**STAFF REPORT ADDENDUM II**  
**APPLICATION RZ/FDP 2005-MV-001**  
**MOUNT VERNON DISTRICT**

<b>APPLICANT:</b>	Brookfield Ridge Road, LLC
<b>PRESENT ZONING:</b>	R-1
<b>REQUESTED ZONING:</b>	PDH-2
<b>PARCEL(S):</b>	89-4 ((1)) 56, 57A and 69
<b>ACREAGE:</b>	11.04 Acres
<b>DENSITY:</b>	1.82 du/ac
<b>OPEN SPACE:</b>	45%
<b>PLAN MAP:</b>	Residential, 2-3 du/ac
<b>PROPOSAL:</b>	Request to rezone to the PDH-2 District for the development of 20 single family detached dwelling units. (Two alternative plans are currently propose differing primarily in the means of providing SWM/BMPs).

Title of Combined CDP/FDP:	Renfro Property
Prepared by:	Land Design Consultants
Original and Revision Dates:	June 2004, as revised through January 23, 2006
Revised Draft Proffer Statement:	January 26, 2006

EXISTING VEG. MAP & EX. CONDITIONS PLAN OPT. A

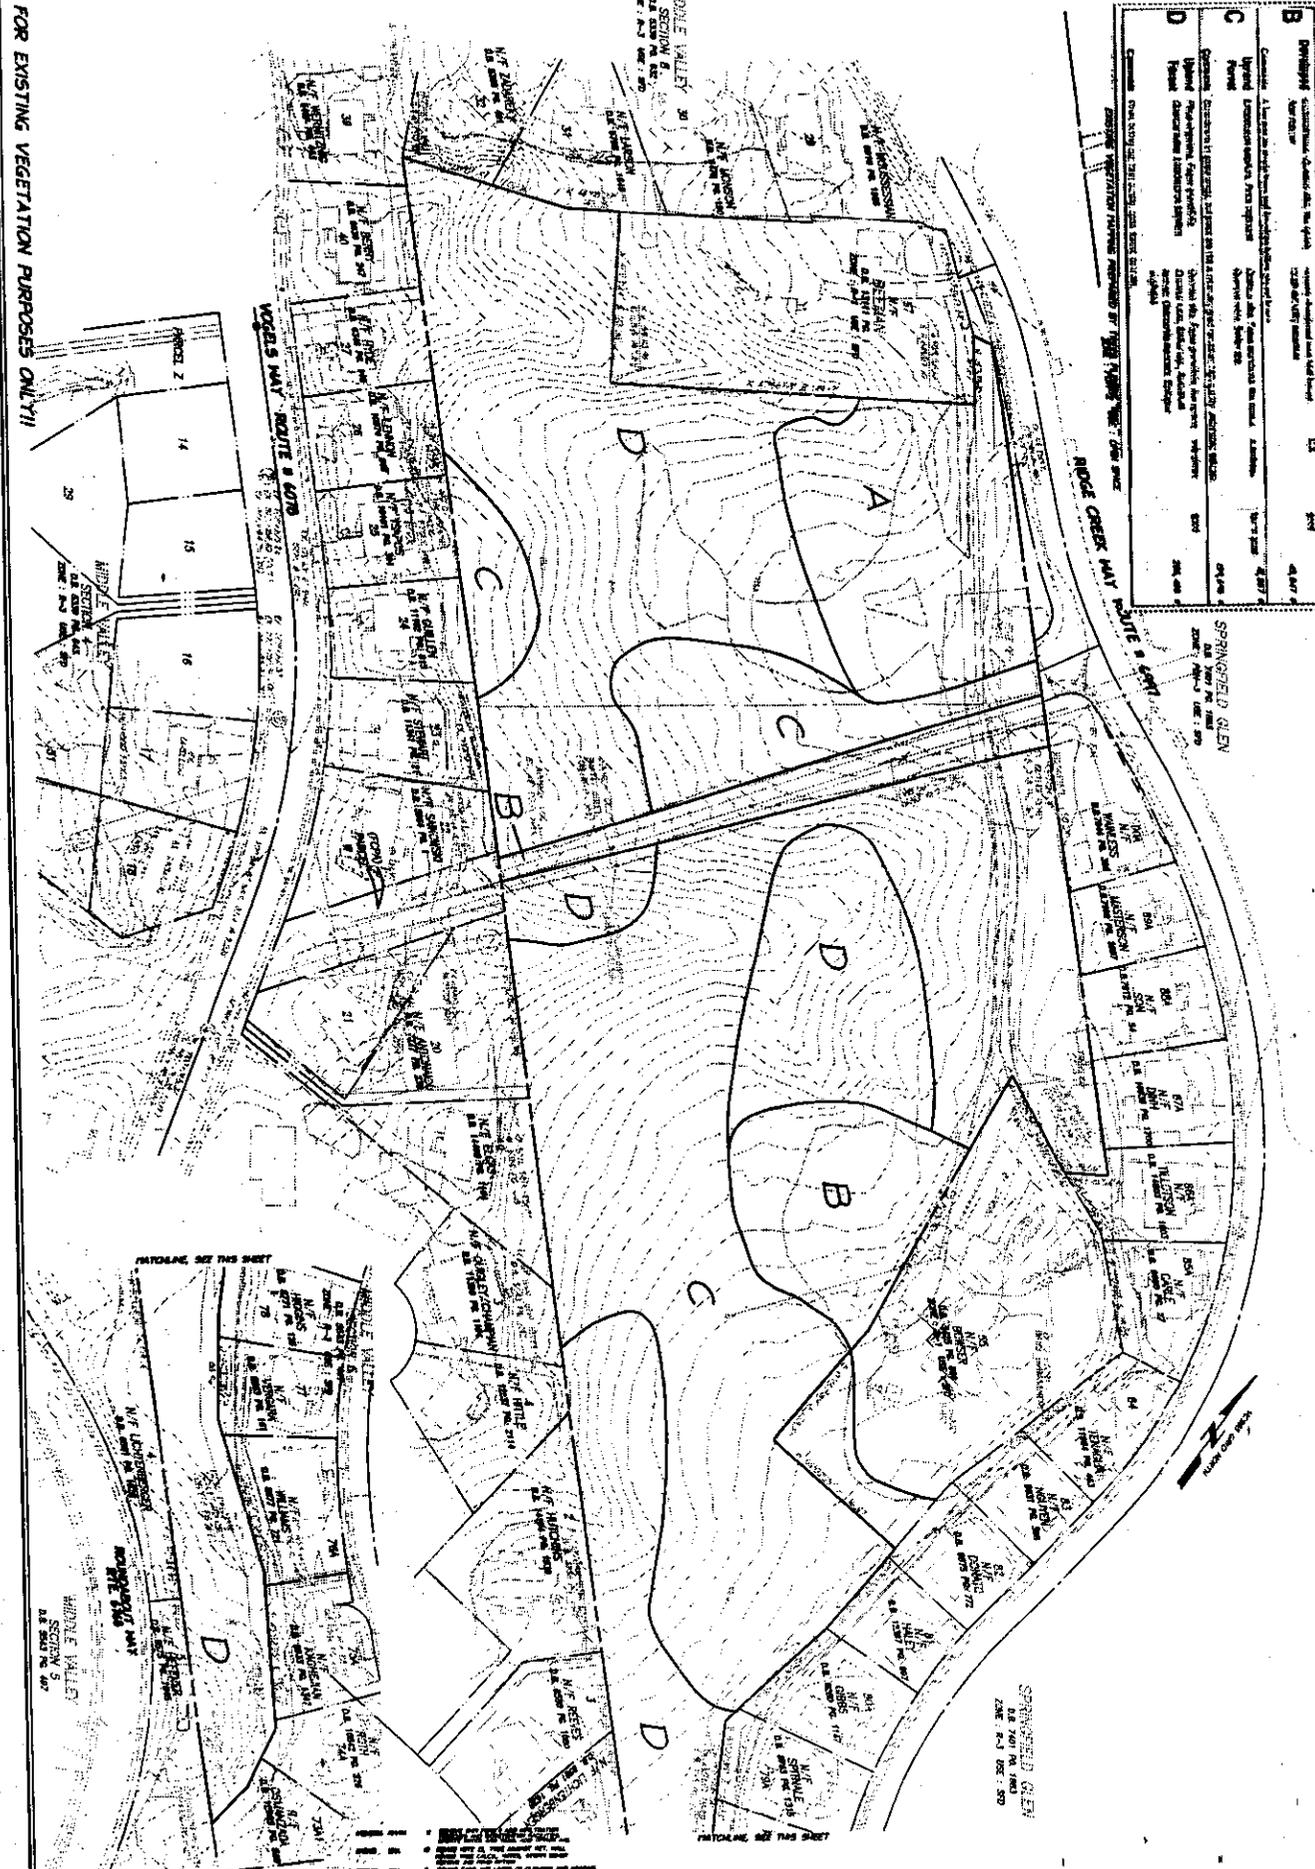
In an effort to address the concerns of the neighborhood, which continue to center around site drainage and stormwater management, the applicant submitted a revised CDP/FDP, which now includes two options for development. The first Option, Option A, is depicted on Sheet 2 of the CDP/FDP; this option shows a traditional

CONCEPTUAL DEV. / AN/FINAL DEV.  
 PLAN - OPT. B

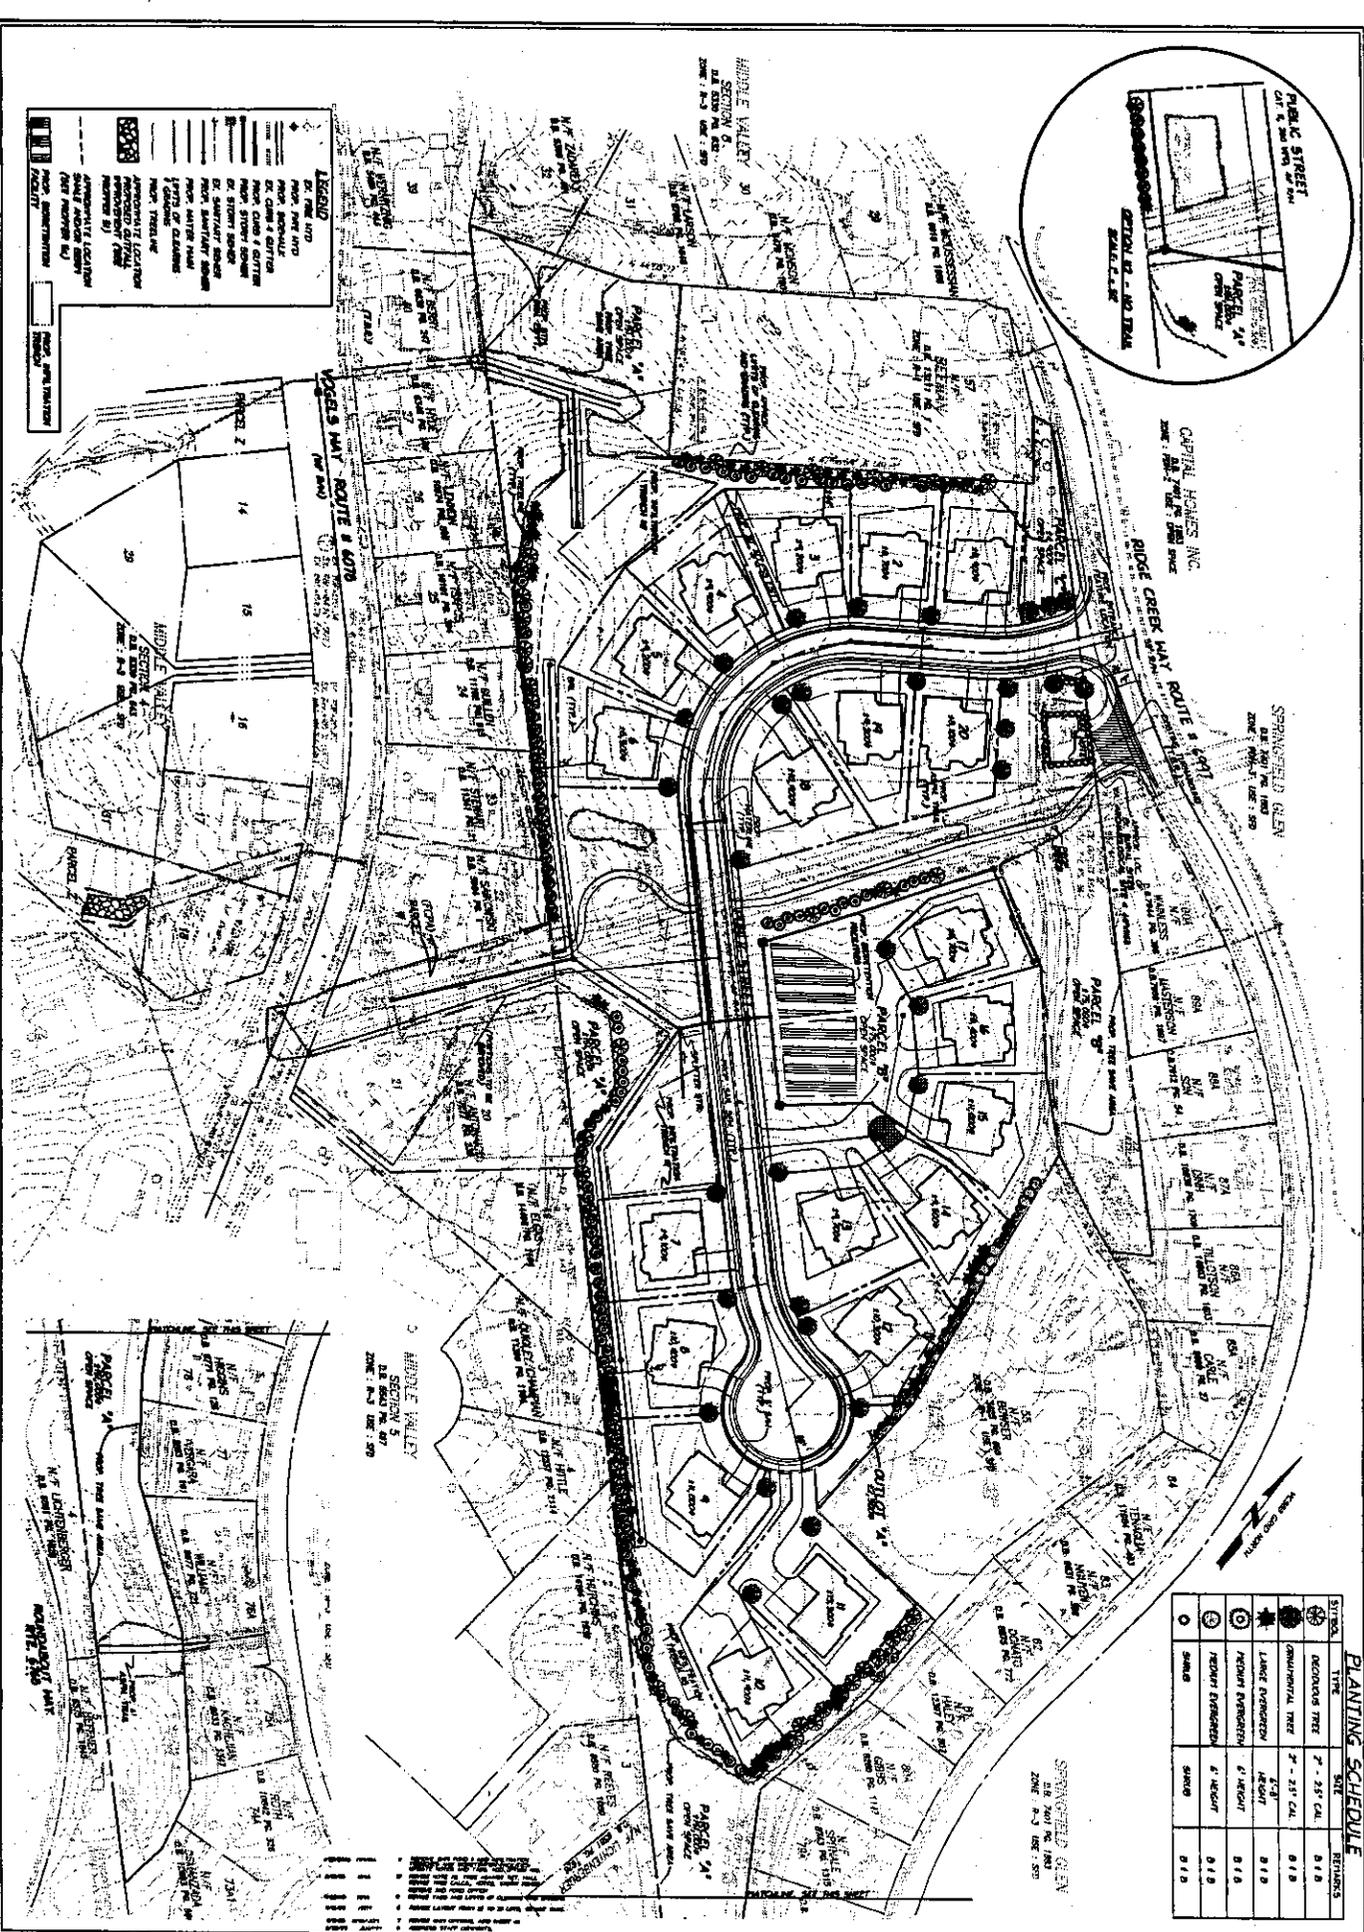
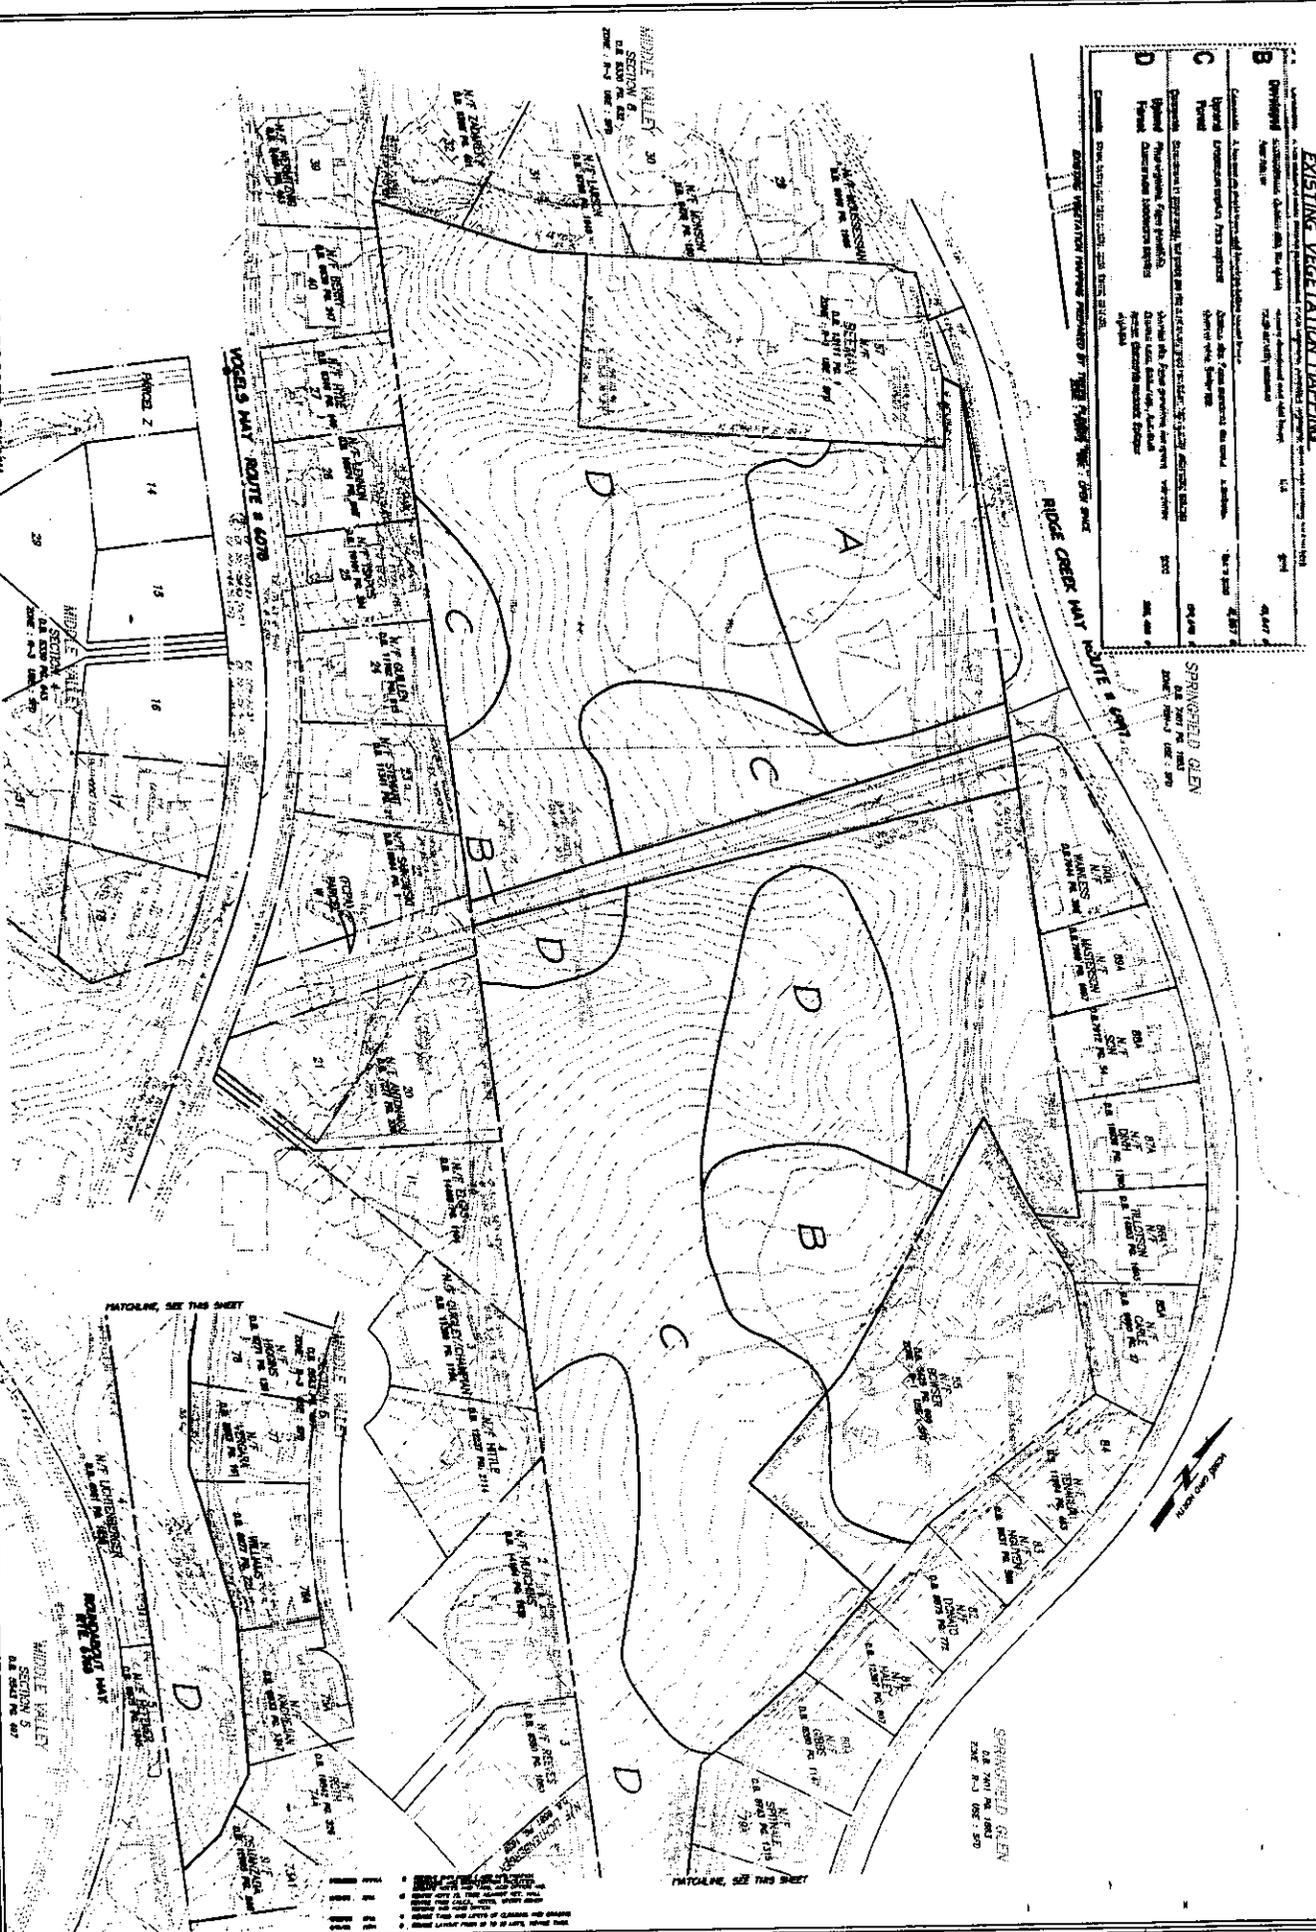
central stormwater management facility (dry pond) which remains essentially unchanged from the previous submission. The focus of this Addendum is Option B, which is depicted on Sheet 8 of the CDP/FDP. Although the two options both depict 20 single family detached dwelling units in an almost identical site layout, Option B employs innovative, low-impact development (LID) techniques to manage stormwater quantity and quality on the site. Specifically, Option B incorporates the following modifications:

- A stormwater drainage pipe in the southwestern corner of Parcel A, connecting to the existing storm drain located between Lots 27 and 40 on Vogels Way, has also been added with this Option.

The applicant has stated that the infiltration trenches have been sized to provide control of storm water runoff in excess of the 100 year storm volume in response to the downstream drainage issues. Staff believes that the applicant should provide proffer commitments to the additional amount of control that is proposed.

The applicant has also stated that the proposed bioretention filters (raingardens) are designed to provide quantity control for up to the 10 year storm. Innovative facilities not included in the PFM at this time are approvable by the Director in accordance with PFM 6-0402.4.

In order to address concerns about the functioning of the proposed infiltration trenches on the application property, the applicant had a geotechnical review conducted. Staff's evaluation of the Subsurface Exploration Report concludes that the geotechnical engineers made very conservative assumptions that actually show an increase in flow of groundwater towards the houses downhill. (These assumptions included a fully saturated ground condition, a condition which is unlikely to occur in nature given the permeability of the soil types; and a shallow elevation for both the ground water table and the bedrock, both of which would favor more water flowing downhill.) Staff identified three deficiencies in the report which should be addressed to the satisfaction of DPWES, should Option B be selected as the preferred alternative:
